# **THE SILK ROAD, BOLLINGTON**

## **PROPOSED PEDESTRIAN CROSSING**

### **Road Safety Audit Stage 1**

Project: The Silk Road, Macclesfield  
Document Title: Road Safety Audit Stage 1  
Ref. No: CEH/RSA/16-17/16

Photograph 1 – Lack of drainage , Northbound

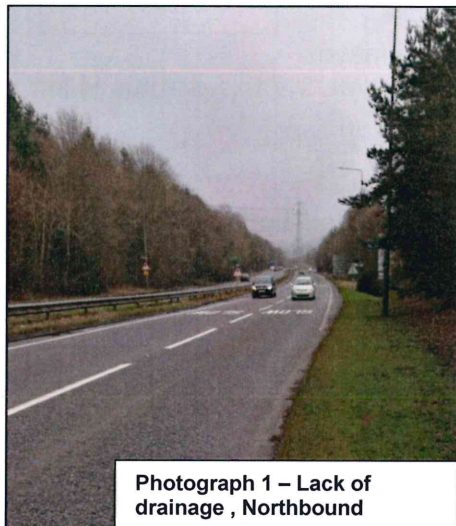
**Summary:** Lack of drainage at crossing points.

**Description:** The proposed crossing points will lie inbetween existing gully locations. The Audit team feel that this may not remove all standing water from immediately in front of the proposed dropped crossing. Any standing water could lead to a slipping hazard for Non Motorised users (NMU's), particularly during cold weather where ice may form and significantly increase the risk of falling.

**Recommendation:** It is recommended that drainage is provided to prevent any standing water from gathering in front of the proposed crossing facility.

Problem number	Problem Accepted Yes/No	Recommendation Accepted Yes/No	Design Engineer's comments	Scheme promoter's decision and proposed action
A1.1	Y	Y	Channel gradients to be checked. Positive drainage installed where required	
A1.2	Y	Y	Vegetation to be cut back when crossing installed. To be fed in to the Asset Management system

Photograph 2 – View North towards Old Bollington Road approach

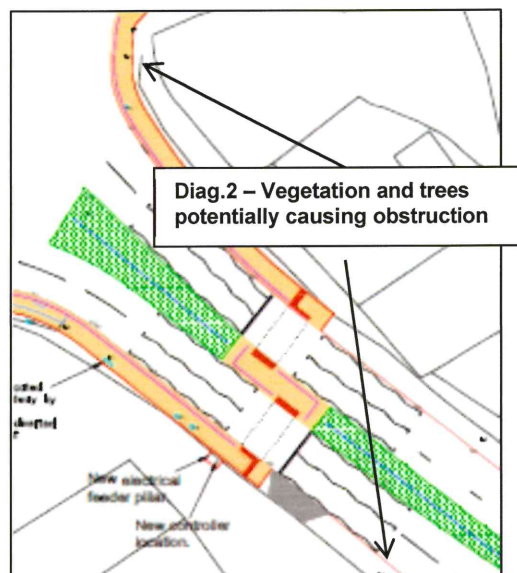
**Summary:** Existing tree line and vegetation may obstruct visibility and fallen leaves may create a slipping hazard..

**Description:** The existing tree line South of the roundabout on the Northbound approach to the roundabout, and the trees and vegetation at the Old Bollington Road approach to the roundabout could obstruct visibility for NMU's, particularly during the summer months when in full leaf. During the autumn and winter months, fallen leaves may present a slipping hazard for NMU's if this detritus is left, particularly during wet weather conditions.

**Recommendation:** It is recommended that maximum visibility is provided for NMU's through regular maintenance of the vegetation and road sweeping.

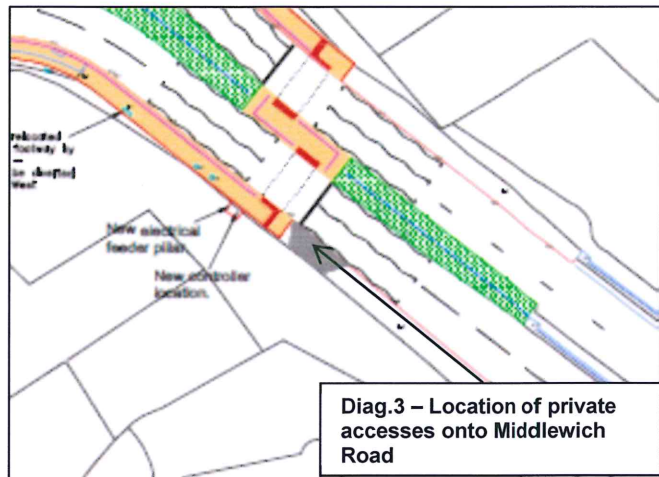
**Summary:** Location of Service vehicle layby.

**Description:** The proposed location of the service vehicle layby could obstruct visibility for NMU's (viewing oncoming vehicles) and drivers travelling Northbound approaching the crossing (viewing pedestrians at the proposed crossing). This could lead to conflict between NMU's and vehicles leading to serious/fatal injuries.

**Recommendation:** It is recommended that the service vehicle layby is relocated to prevent obstructing the view of NMU's and pedestrians.

A1.3	N	N	The reason for the bay location is so that a parked maintenance vehicle does not obstruct the footway. It needs to be on the same side of the road as the controller as this is what the engineer most frequently needs access to. The bay is wide enough so that a parked vehicle should not obstruct the signal head or a waiting ped. Expected usage is very low, it is only likely to be used twice a year for the inspection (one hour each time) and when there is a fault.	<i>Additional</i>
A1.4	Y	Y	Installation of Speed Assessment loops on high speed approaches. Installation of VAS warning signs on approaches. Increase inter green timings of the crossing over the exit from the roundabout	Additional lane markings to be provided on circulatory carriageway.
A2.1	Y	Y	Vegetation to be cut back on installation. Warning signs to be installed on side road approaches/	
A4.1	Y	Y	Lighting columns to be relocated to provide maximum pedestrian / cycle space

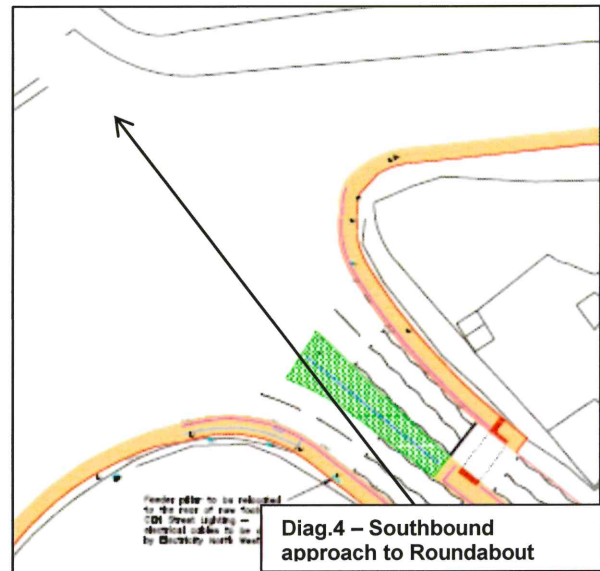
**Summary:** Vehicle speeds exiting the roundabout.

**Description:** During the site visit, the Audit Team observed numerous incidents where drivers exiting the roundabout, travelling Southbound on The Silk Road, were accelerating aggressively and very quickly reaching high speeds. Given the single carriageway approach from the North to the roundabout, and the dual carriageway exit, along with the long straight carriageway upon leaving the junction, this behaviour could potentially lead to serious incidents with vehicles and NMU's, vehicle loss of control and rear end shunts.

**Recommendation:** It is recommended that methods are implemented to reduce the speed of vehicles exiting the roundabout travelling southbound.

Photograph 5 – View North  
towards Old Bollington Road

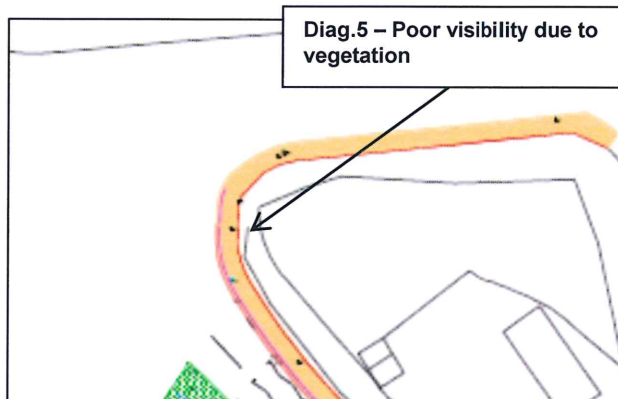
**Summary:** Existing tree line and vegetation may obstruct visibility.

**Description:** The existing tree line and vegetation on the approach to the roundabout from Old Bollington Road will obstruct visibility of the proposed crossing point for drivers wishing to continue onto The Silk Road. This could lead to potential sharp braking manoeuvres, stop line overrunning, loss of control, rear end shunts and conflict with NMU's at the proposed crossing point.

**Recommendation:** It is recommended that maximum visibility is provided for drivers on Old Bollington Road approaching the proposed signalised crossing point on The Silk Road. Advanced warning is also recommended.

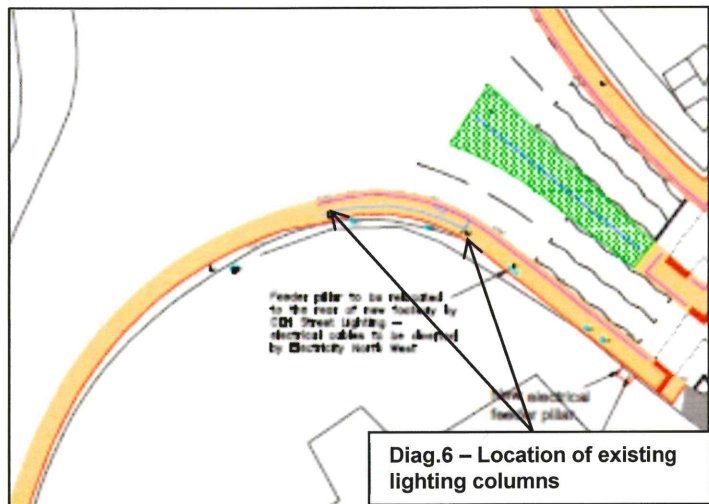
**Summary:** Lighting  
columns in proposed  
footway.

**Description:** The design proposal shows that two existing lighting columns will retain their existing position within the middle of the proposed footway. This could lead to potential conflict for NMU's, particularly if opposing flows of NMU traffic meet at these locations, leading to tripping and falling hazards.

**Recommendation:** It is recommended that footway space is maximised for NMU's to prevent narrowing and potential conflict.
